RE: **60 BAY AVE HIGHLANDS, LLC**
Response Letter (HLPB2024-02)
Block 42, Lot 1;
60 Bay Avenue
Borough of Highlands, Monmouth County, New Jersey

We are submitting this letter on behalf of the Owner/Applicant in response to Roberts Engineering Group LLC's Review Letter dated May 21, 2025. Each comment and response are numbered in accordance with the aforementioned review memo. *Italicized text is taken from the review memo for your ease of reference;* non-italicized text represents our responses.

Review Letter, dated May 21, 2025

PRELIMINARY & FINAL MAJOR SITE PLAN FOR PROPOSED MULTI-FAMILY RESIDENCE

LIGHTING PLAN -
PROPOSED CONDITIONS

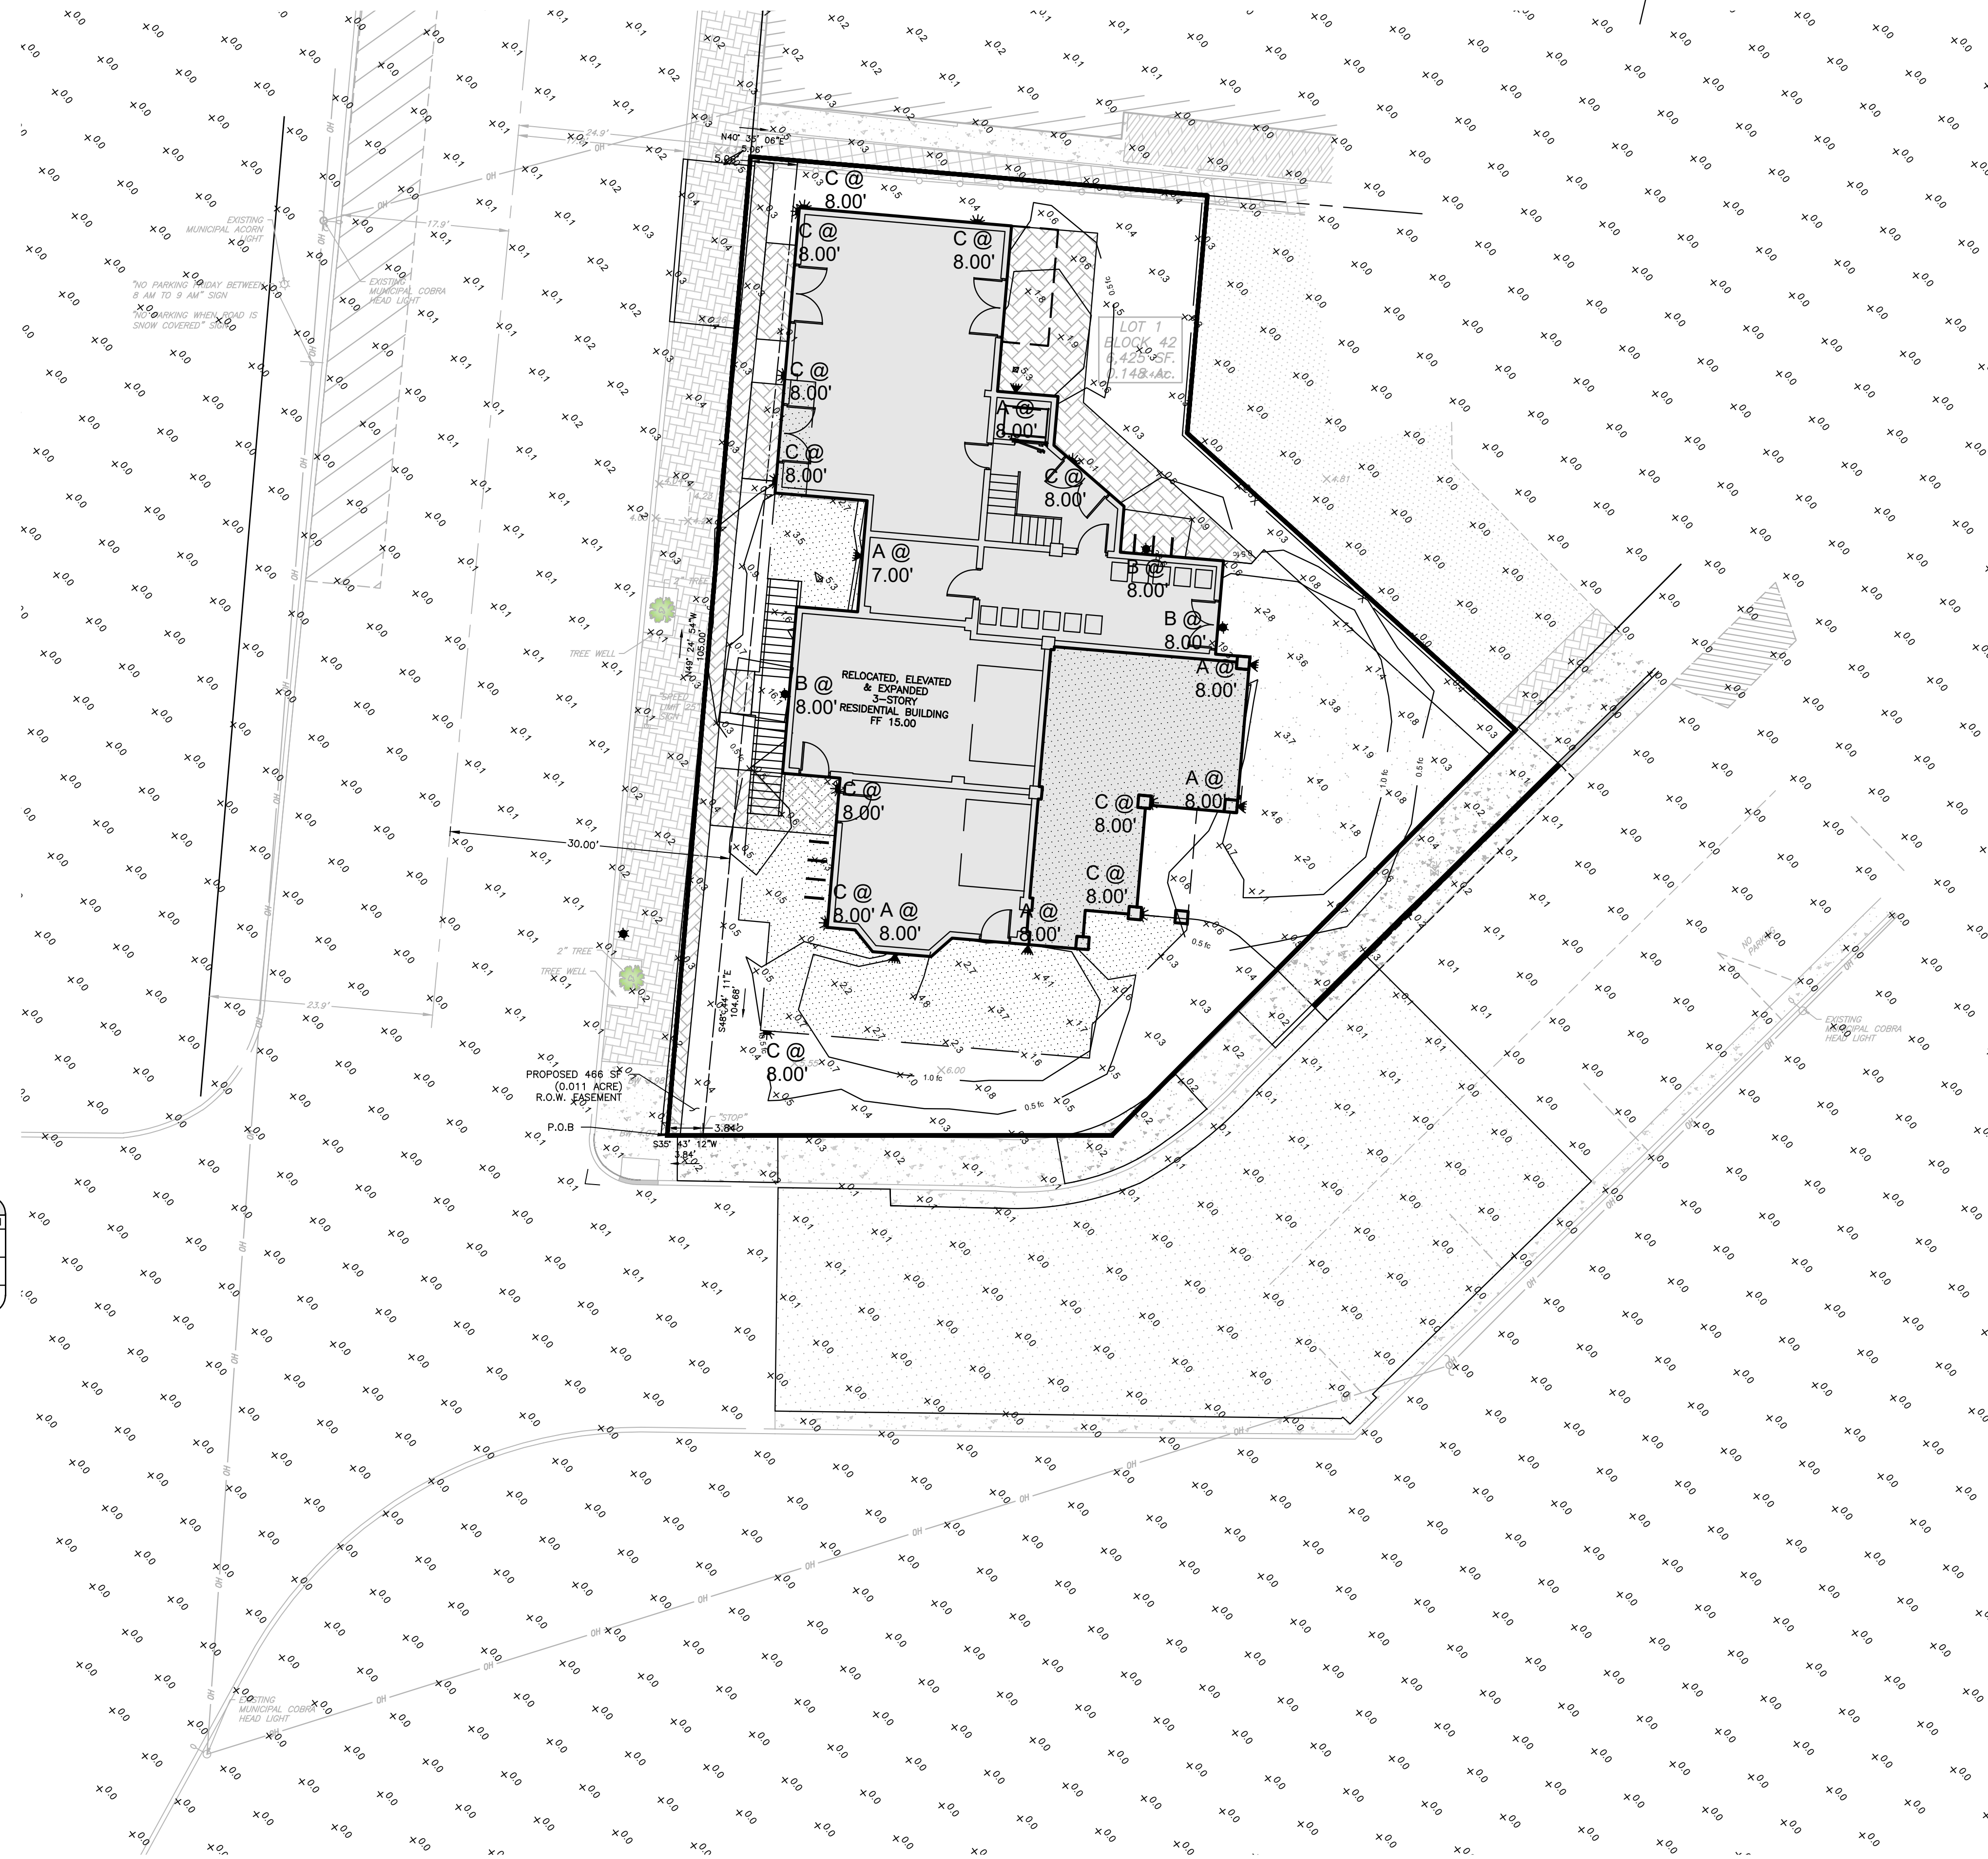
7. *The lighting plan needs to be updated based on the additional 1 foot in FF elevation which may affect the mounting height of the proposed lighting units placed along the walls of the building relative to the ground.*

The lighting plan was revised accordingly.

STANDARD LATERAL CONNECTION WITH CLEANOUT - SEWER DEPTH 10' OR LESS
NTS

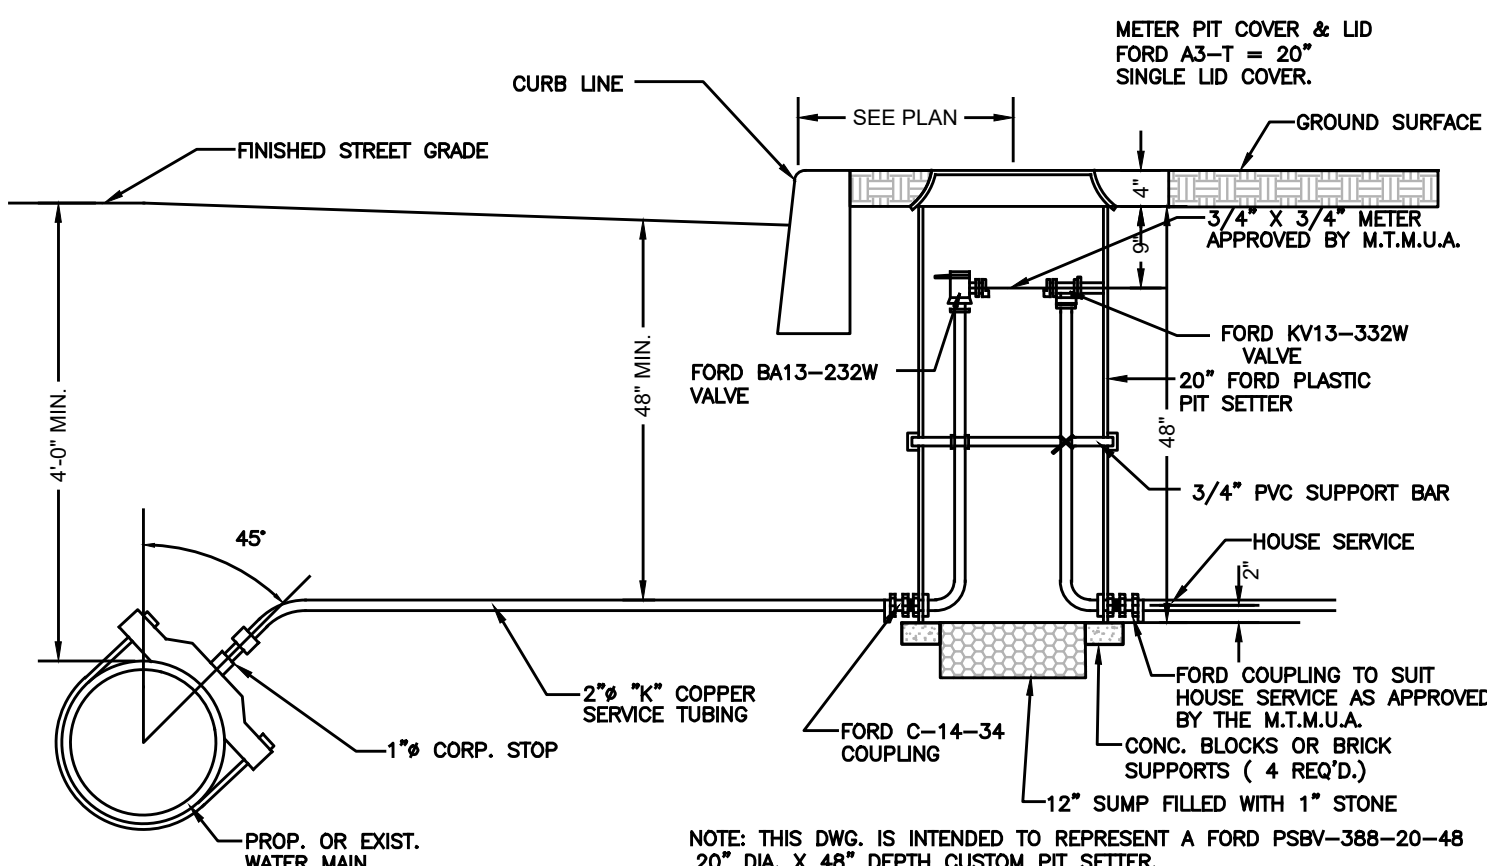
9. *Provide the material type and size of the sanitary lateral on the “Standard Lateral Connection with Cleanout...” detail.*

On same detail, there is a reference to a detail entitled, “Bedding and Initial Backfill Detail for PVC Sewer Pipe”, however it is missing on the sheet. There is a Pipe Bedding Detail. Please update the detail.

The plans were revised accordingly.

DEPRESSED CURB, DRIVEWAY APRON & SIDEWALK

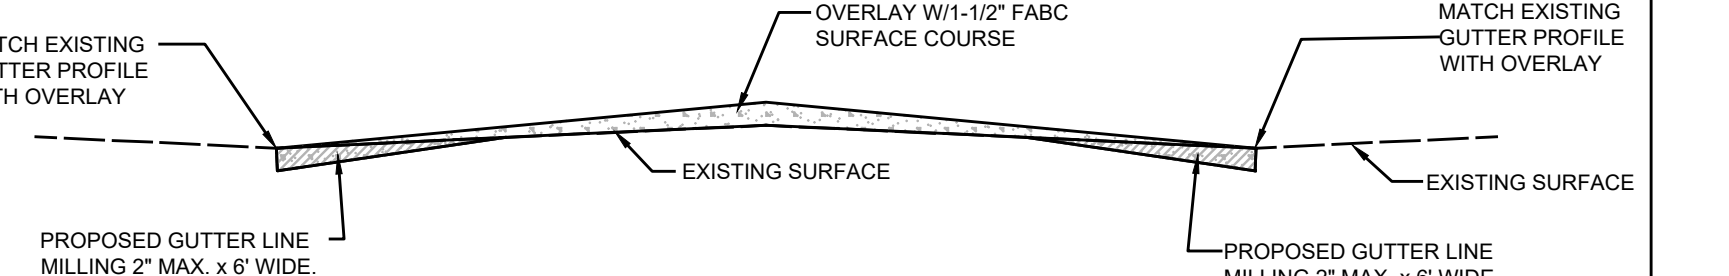
8. *The Depressed Curb, Driveway Apron & Sidewalk construction detail indicates a 6 ft. wide sidewalk and apron. The plan appears to have a 5 ft. wide sidewalk. Please update the detail accordingly.*

The plans were revised accordingly.
